Re: Certification Submittal for a Permanent Building Certificate of Occupancy (C.O.)
for La Promesa Charter School, [L-10 / D007]
6800 Gonzales SW
Architect's Stamp Dated 04/05/11

Re: La Promesa Charter School, 6900 Gonzales Rd SW, Traffic Circulation Layout
Architect's Stamp dated 11-01-10 (L10-D007)

**Re: La Promesa Charter School, Gonzales & Coors
Grading and Drainage Plan
Engineer's Stamp dated 09-07-10 (L10-D007)**

Re: Reduction in Retention Pond capacity at Nuestros Valores Charter School, Albuquerque, NM

New Portable Buildings Layout

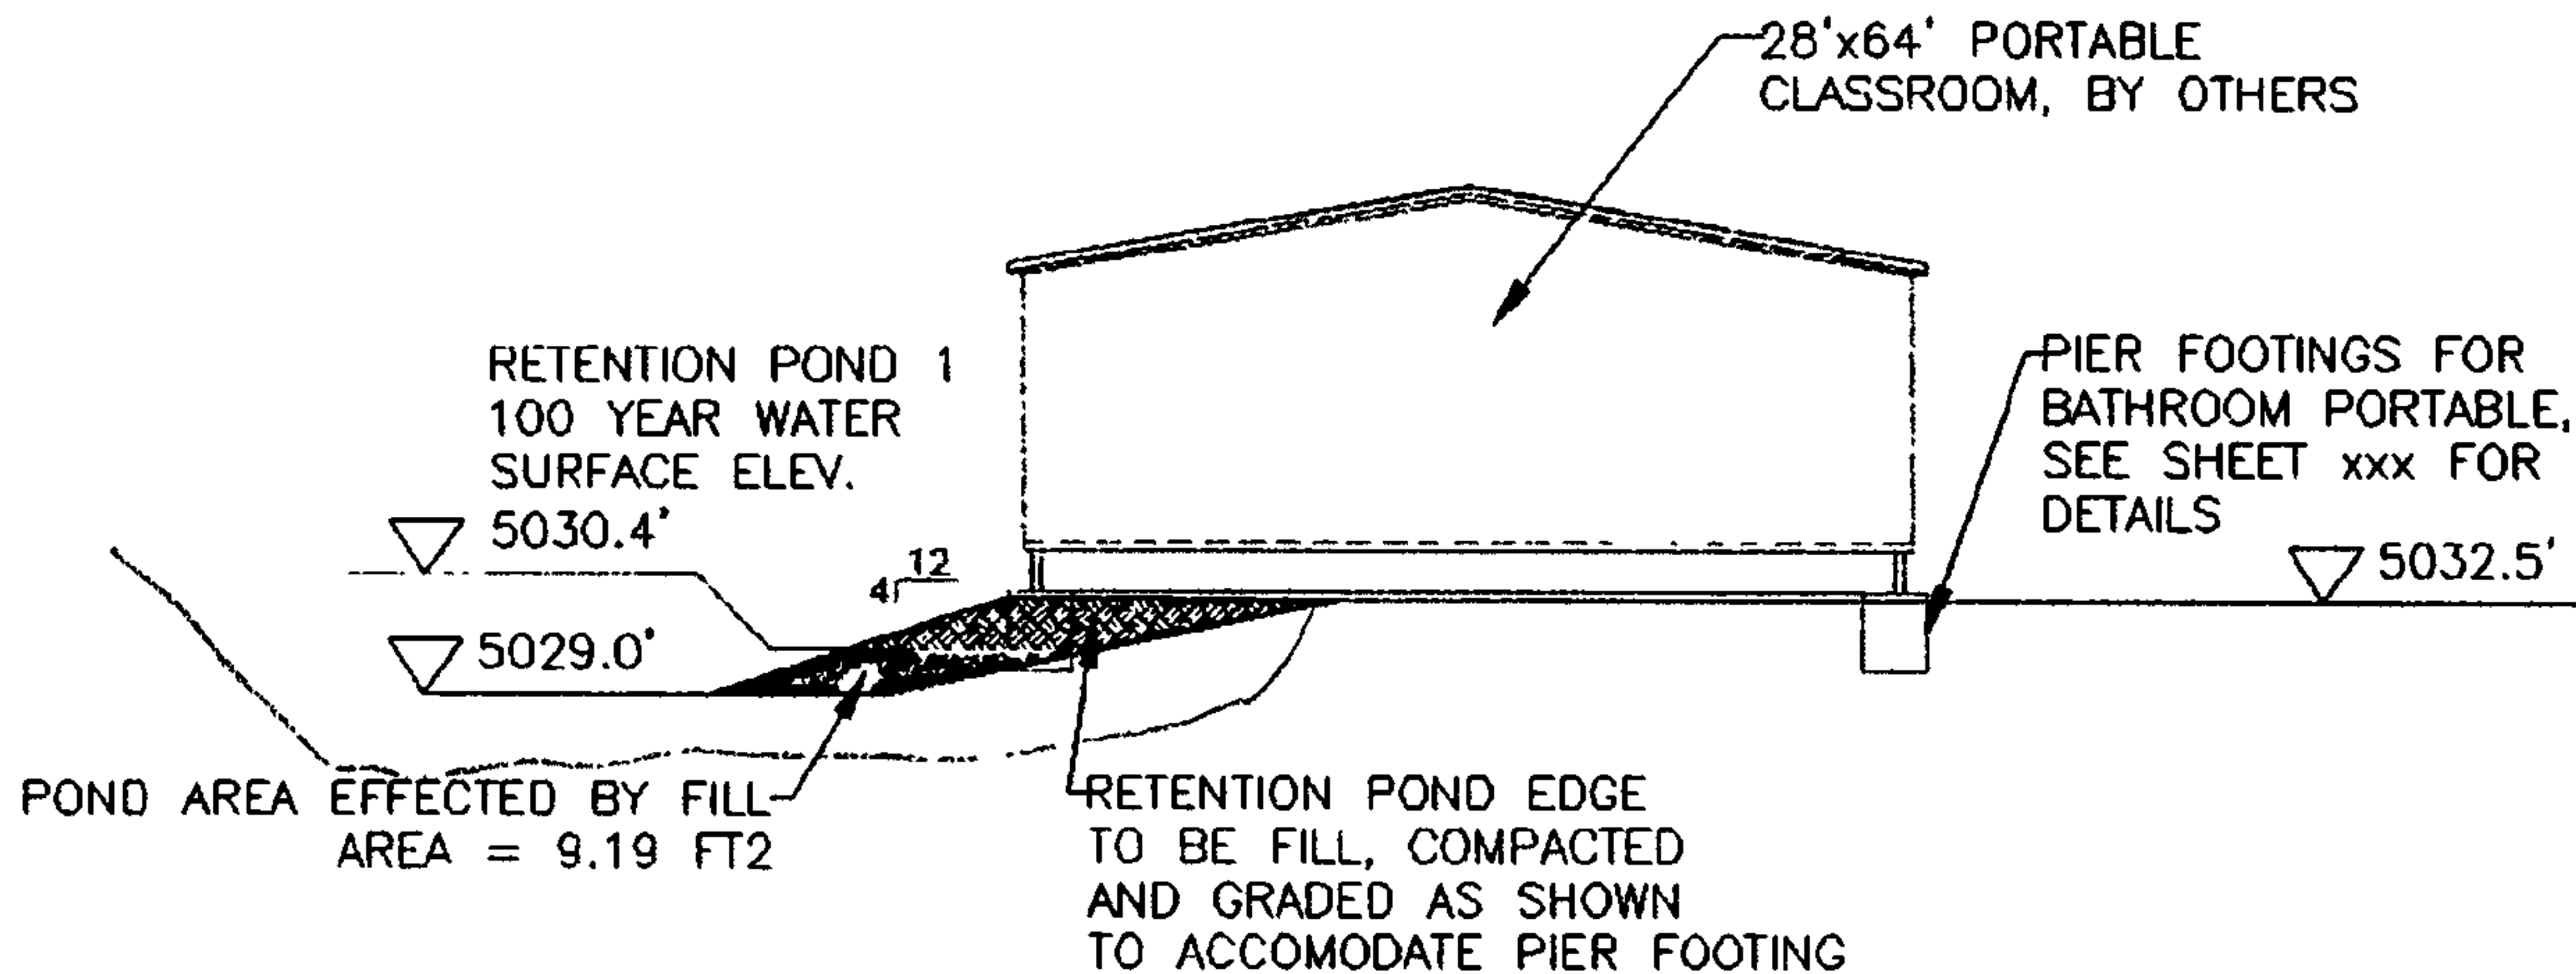
Because of the sizes of the new portable classrooms and the architectural requirements between the classrooms, the new buildings were sited so as to encroach upon retention ponds 1 and 2 along their southern and northern edges, respectively. In addition, the building layout will extend into the drainage link between retention ponds 1 and 2 along the western edge of the link. Retention Pond 3 is not affected by the new building locations. This layout is shown in the figure shown below.

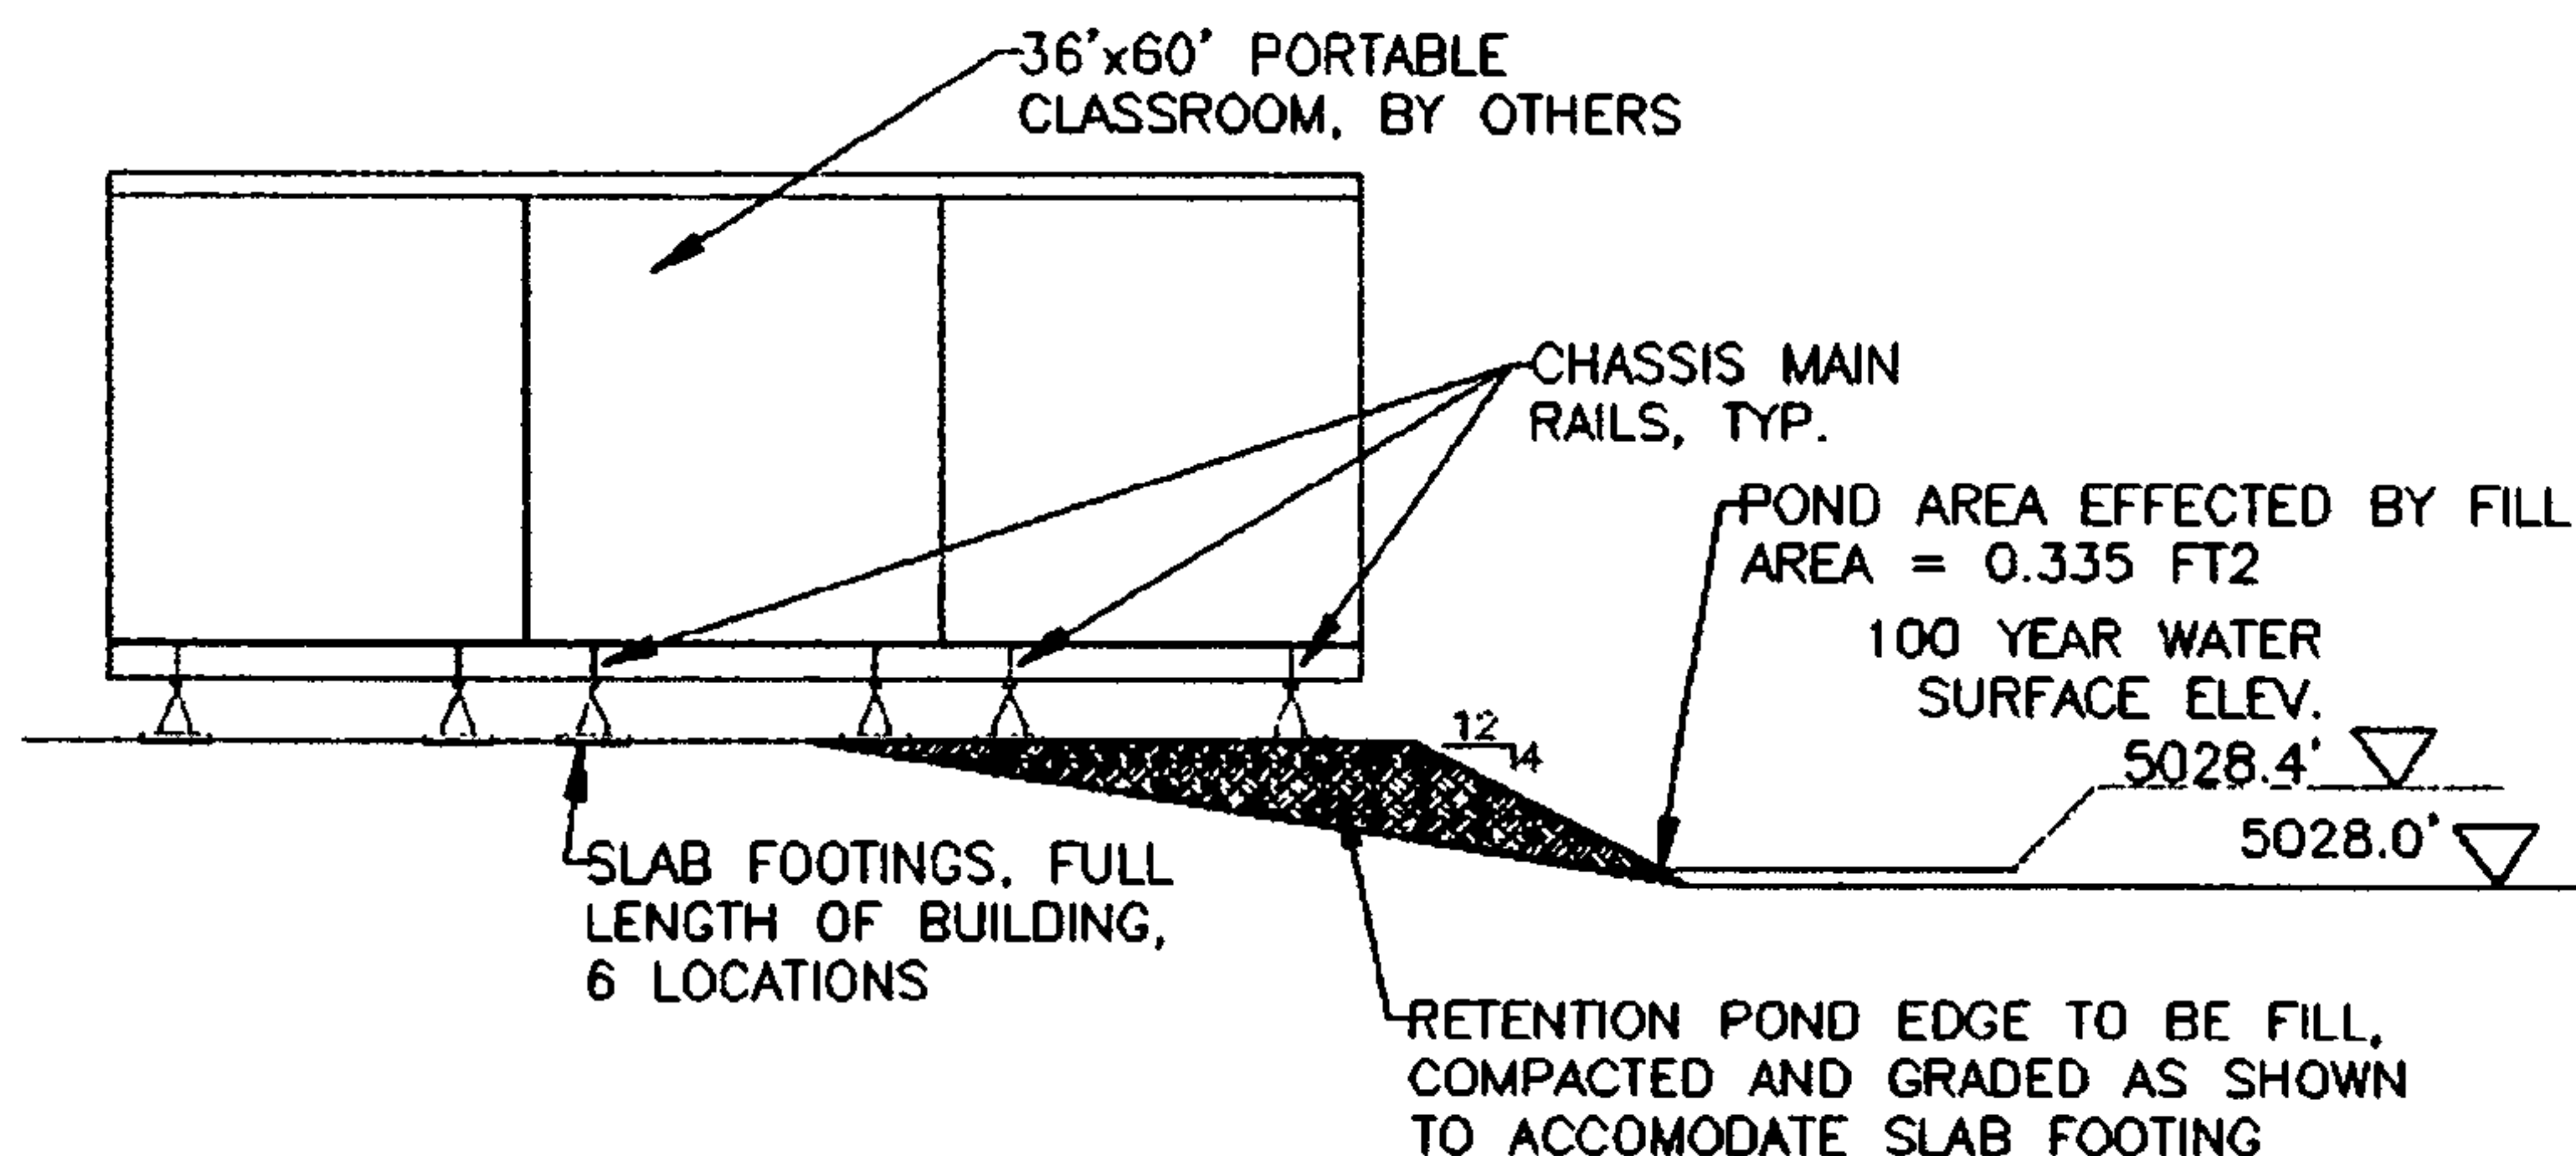
Starting with Retention Pond 1, we have drawn the cross section through the pond and adjacent building which shows this encroachment. It should be noted that this condition occurs only along a 31'-10" length of the southern portion of retention Pond 1 and not along the entire length of the southern side. This length is itself conservative since it does not account for the corner bend of the pond. This condition is shown below.

The area of fill that affects the capacity of Retention Pond 1 as shown above is 9.19 ft². This occurs for a conservative length of 31'-10" along the southern edge of Retention Pond 1. The corresponding volume that is removed from water storage of the pond based upon the 100 Year Water Surface Elevation is conservatively calculated at 293 ft³. This reduces the capacity of Retention Pond 1 from 11,566 ft³ to 11,273 ft³, a 2.6% reduction in the retention pond capacity and still above the required capacity of 11,099 ft³.
